Public Comment No. 2217-NFPA 70-2018 [Global Input]

Committee: NEC-P12

Figure Informational Note Figure 620.2, No. 2 Control System.

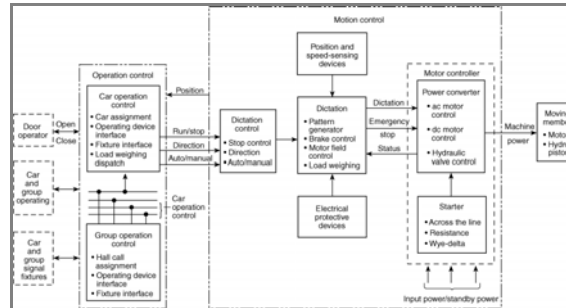
NOTE: This Public Comment appeared as CC Note No. 172 in the First Draft Report on First Revision No. 8214 and Public Input No. 1913.

Committee Statement: The Correlating Committee directs the panel to take action on PI 1913 to correlate with other actions taken throughout the code with respect to the application of definitions in the XXX.2 sections. This action will be considered as a public comment.

Figure Informational Note Figure 620.2, No. 2 Control System.

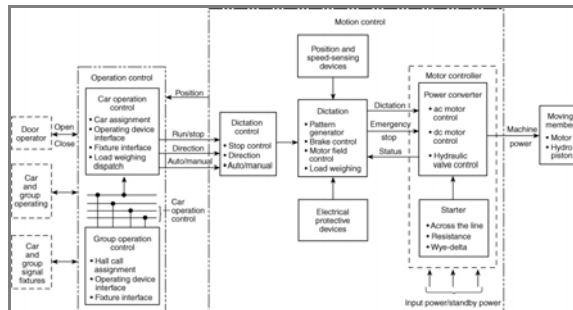
Statement of Problem and Substantiation for Public Comment
